SHOREHAM  
DEFUELED SAFETY ANALYSIS REPORT (DSAR)

Insertion Instructions  
for Incorporating Revision 4

Figure 13.1-1  
LIPA Corporate and Plant Organization  
Defueled Safety Analysis Report  
Revision 4 July 1992

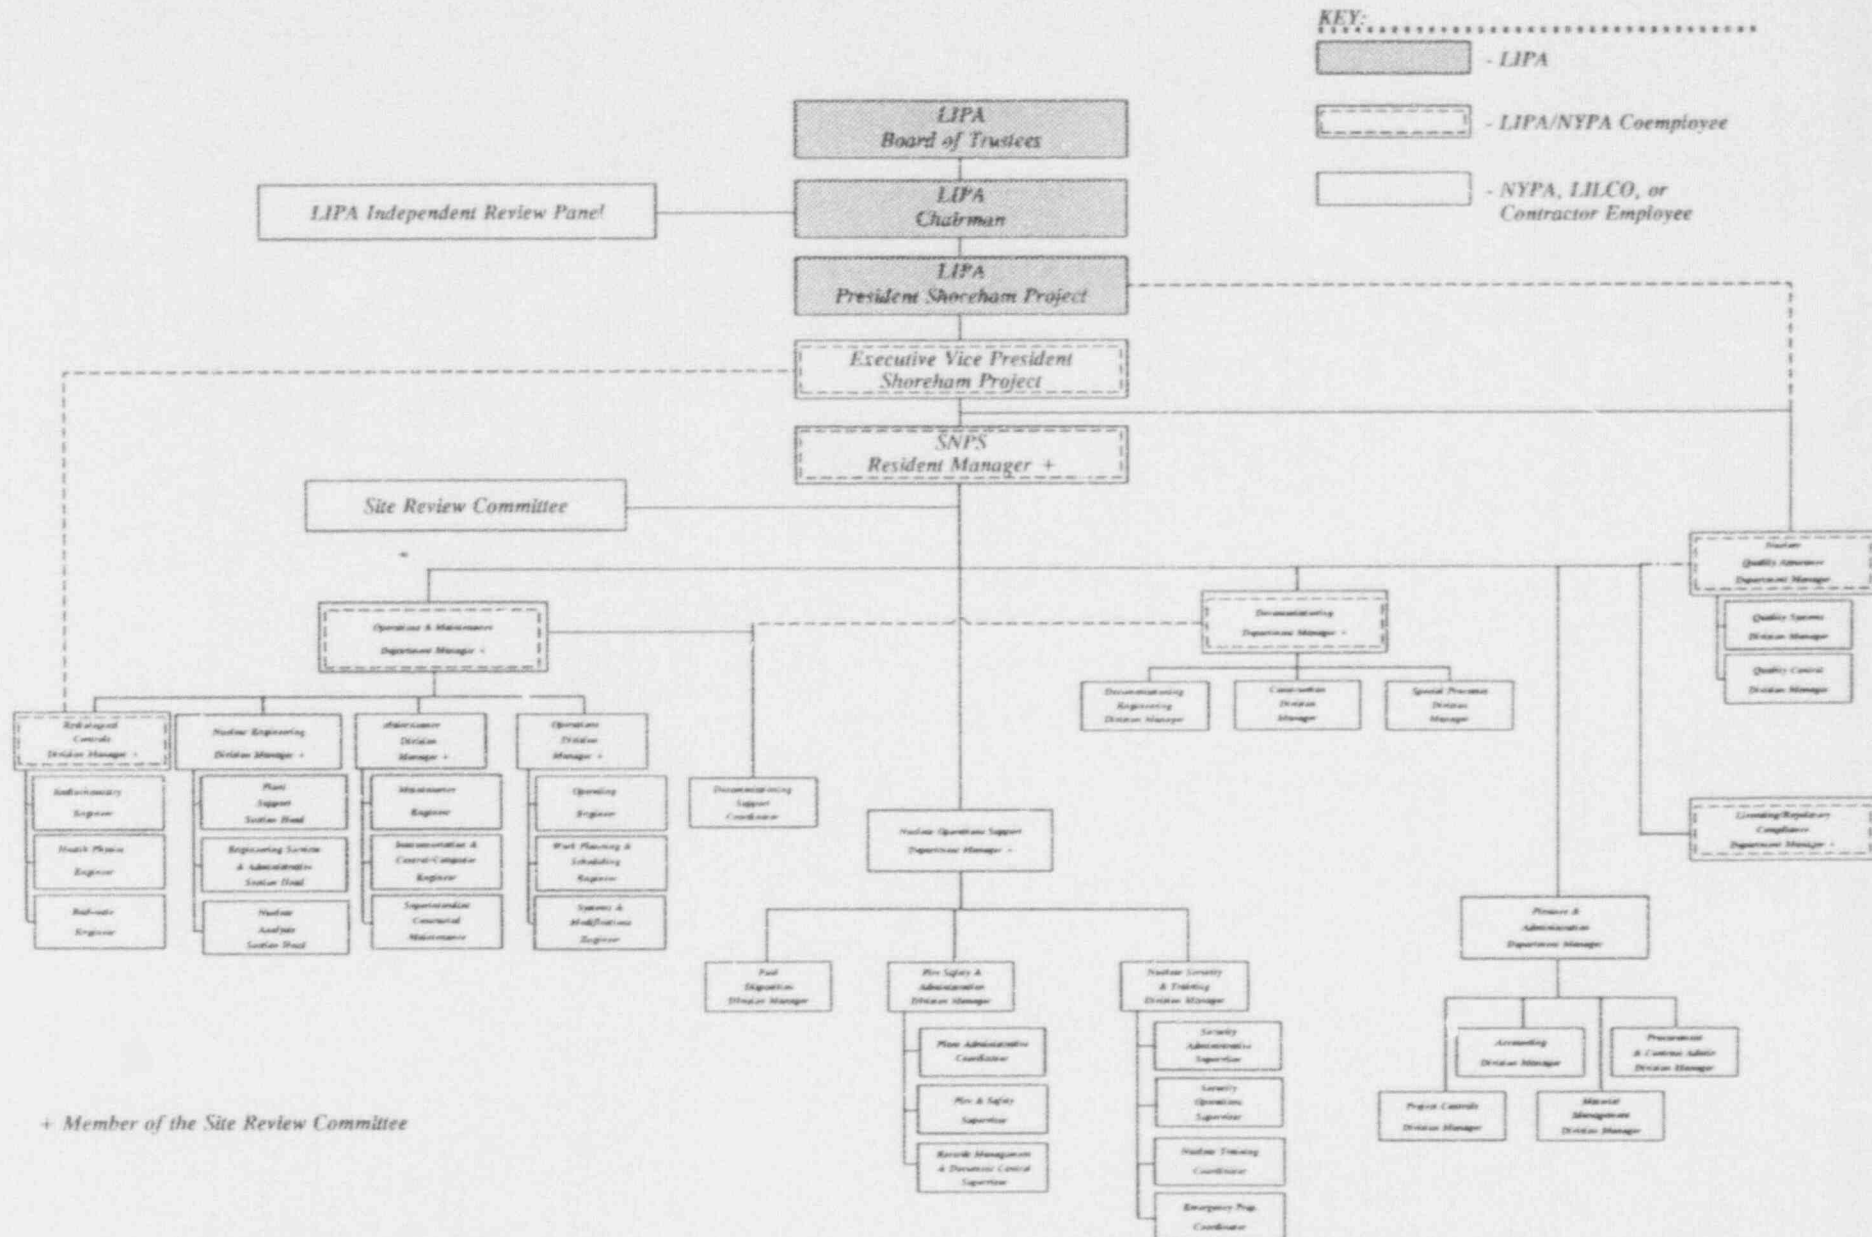
Figure 13.1-1 depicts the corporate and plant organization of LIPA for the maintenance and decommissioning of the SNPS.

The SNPS organization chart is shown in Figure 13.1-1. This chart depicts the titles and line of authority of the plant personnel in charge of the various plant departments. The station organization shall include all the technically trained personnel necessary to support all aspects of the maintenance and decommissioning of the plant.
